Re: 105 W Palm Valley Blvd Wastewater Service - SCS - Administrative NOD
Proposed by Richard C. Baker, Trustee Joint Venture
Application No.
CN, RN
LJA Project No. A244

**TEXAS COMMISSION ON ENVIRONMENTAL QUALITY
ORGANIZED SEWAGE COLLECTION SYSTEM PLAN**

105 W. PALM VALLEY BLVD. WASTEWATER SERVICE

NELSON HOMESTEAD
SCS DRAINAGE AREA MAP

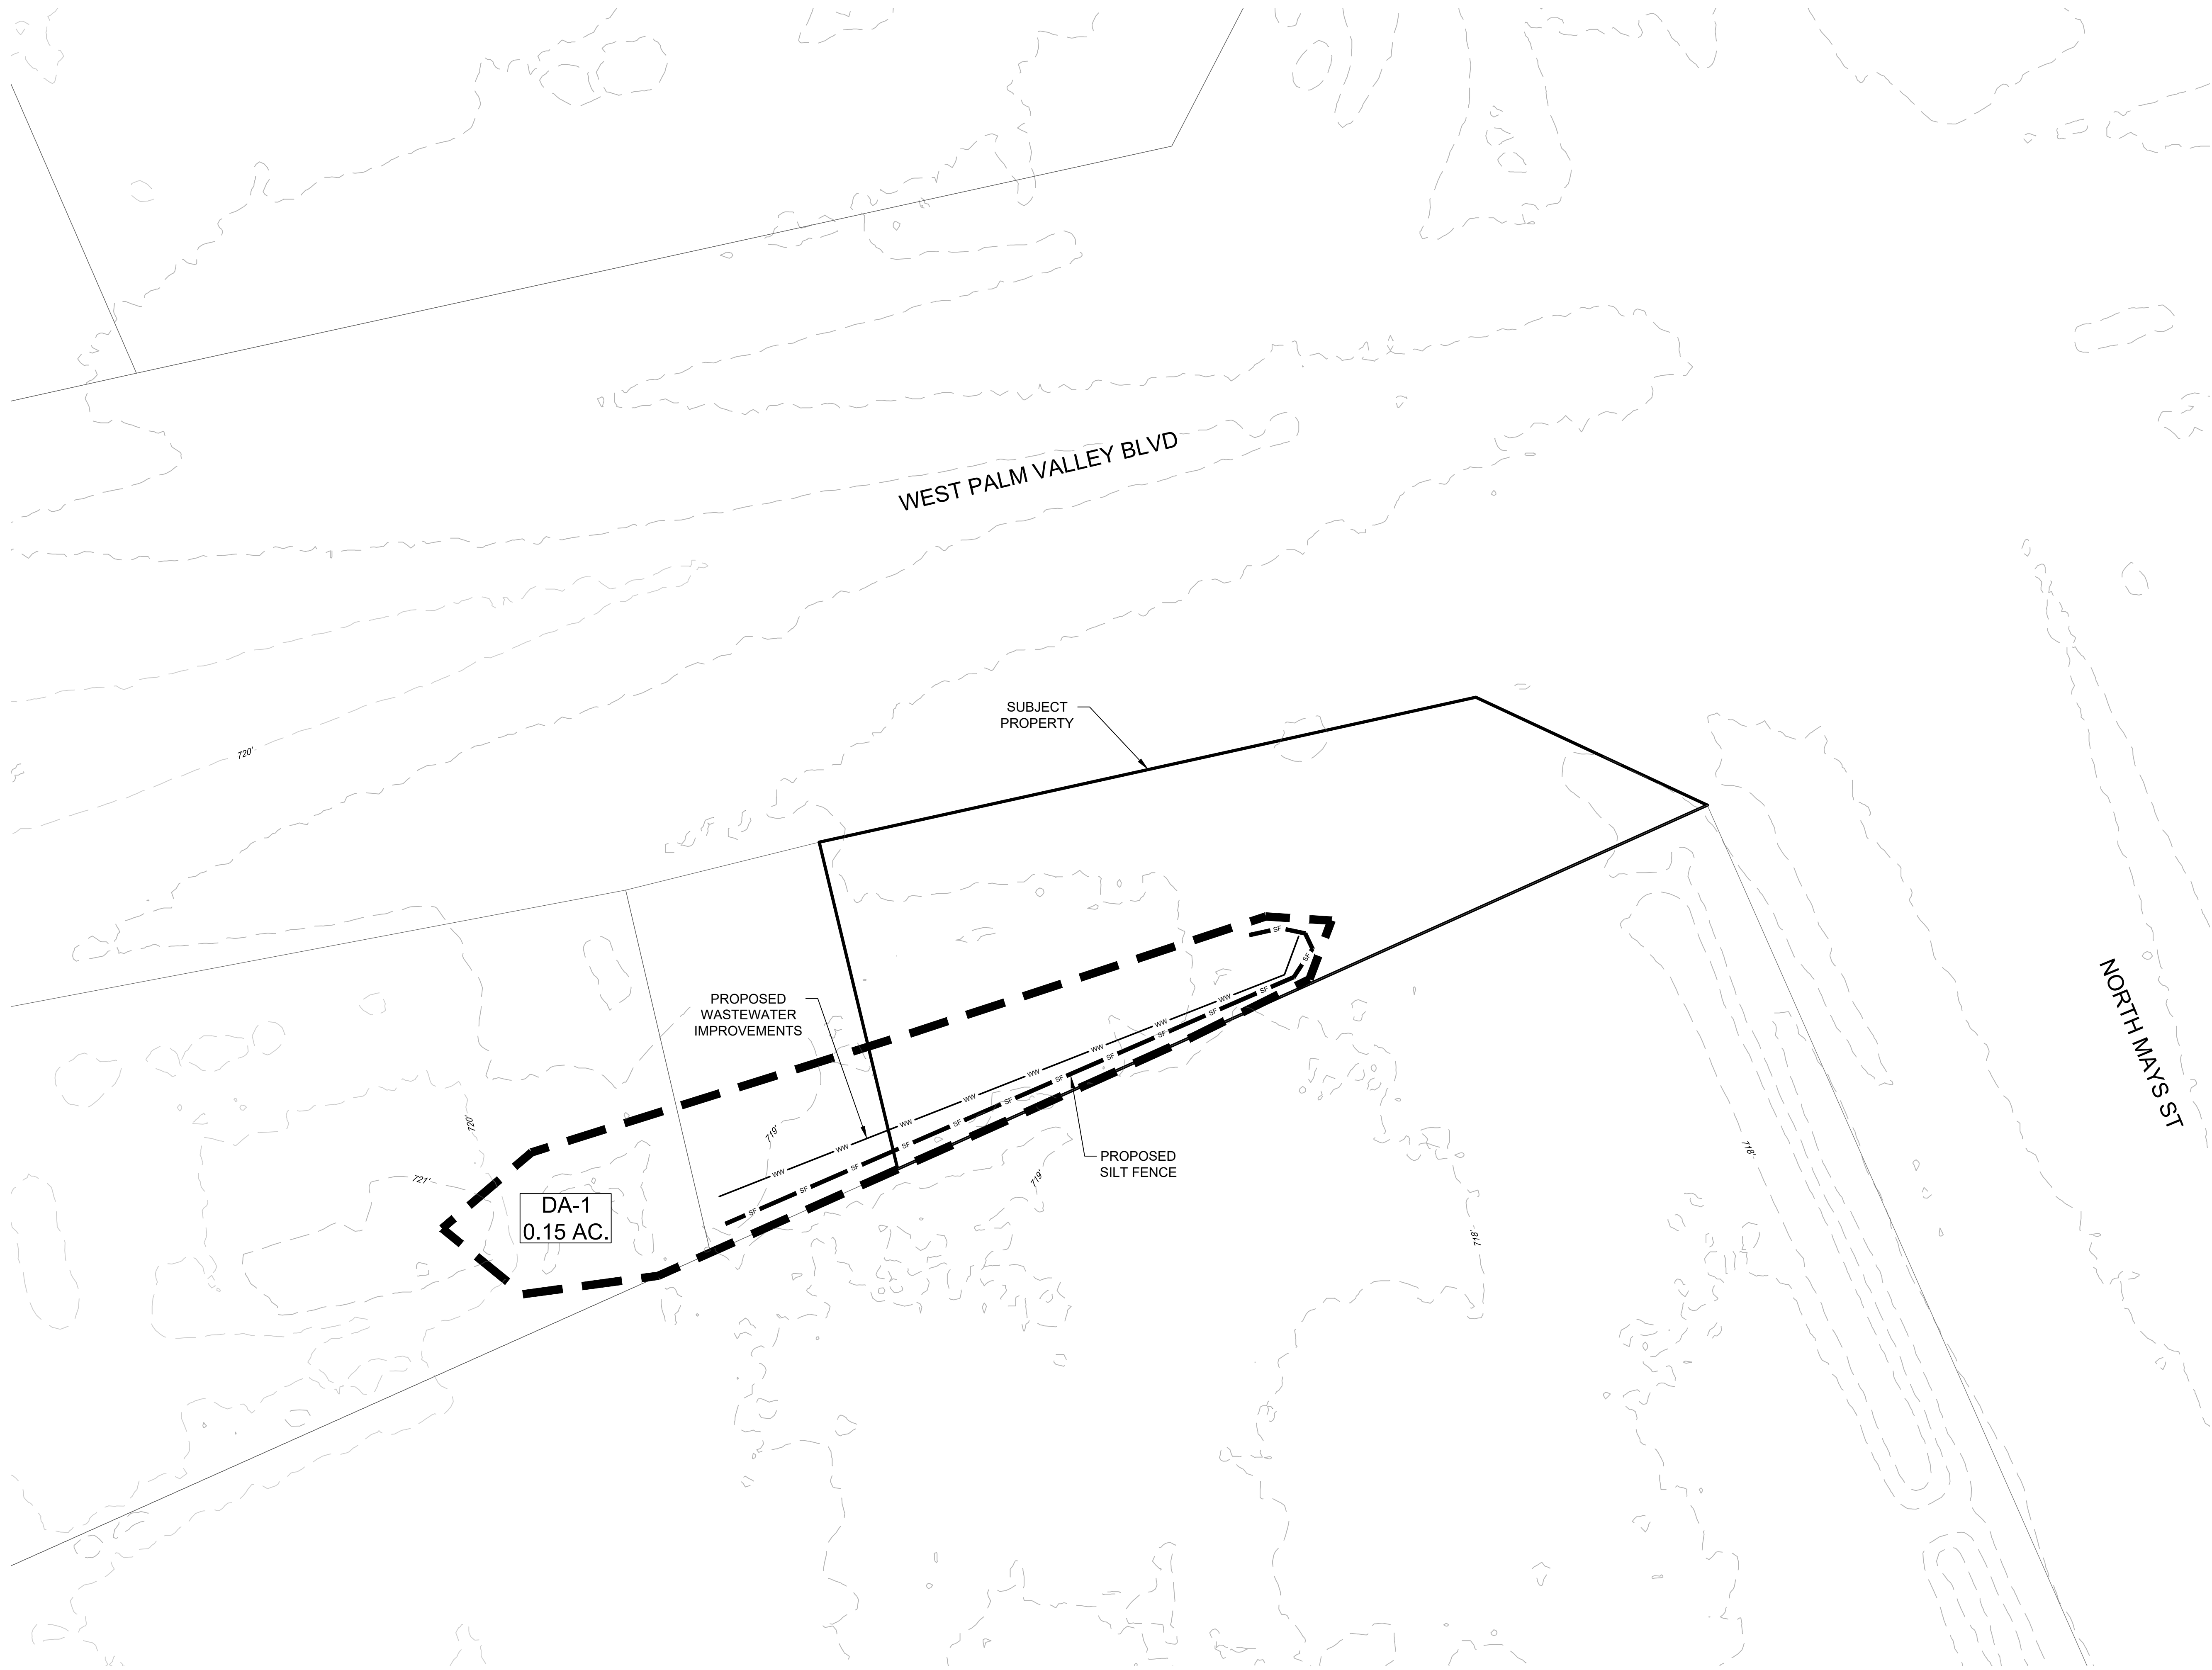
Attachment G - Drainage Area Map

7. Please include attachment.

Response: See attached Drainage Area Map.
